# Access Compliance Report Public Rights-of-Way (Curb Ramps)

Main Street: ETON\_PL Cross Street: O\_NEILL\_DR Location: W

ADA ID: RPRK211103153637 Ramp Type: Type 4 - Parallel Initial Pass/Fail: Fail Overall Compliance: No Severity Score: 16

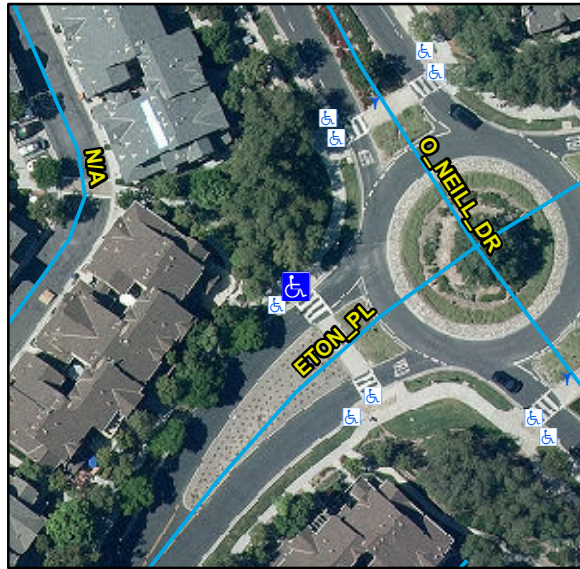
R304.3.2, R304.5.3, STD 1115

| Compliance | Description                   | Data       | Compliance | Description                   | Data |
|------------|-------------------------------|------------|------------|-------------------------------|------|
| N/A        | Ramp Run Slope LT (%)         | -9999      | No         | Ramp Run Slope RT (%)         | 8.4  |
| N/A        | Ramp Cross Slope LT (%)       | -9999      | No         | Ramp Cross Slope RT (%)       | 2.4  |

Remove & Replace Entire Ramp.
